G30 (5 series Sedan)			
Produced through November 15, 2016

Front windshield washers spray poorly or not at all.

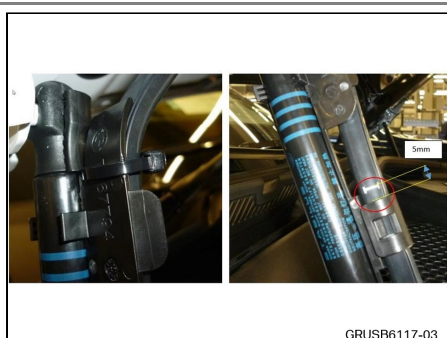
Partially or completely pinched supply tube caused by misplaced tube holder on hood hinge.

Reposition and secure tube holder on the gas pressure spring.

1. Using double-sided tape on the holder where shown, secure the tube holder onto the gas-pressure spring to prevent twisting.

2. Using a cable tie (part number 31 13 1 357 599), attach the tube to the holder observing the dimensions shown.
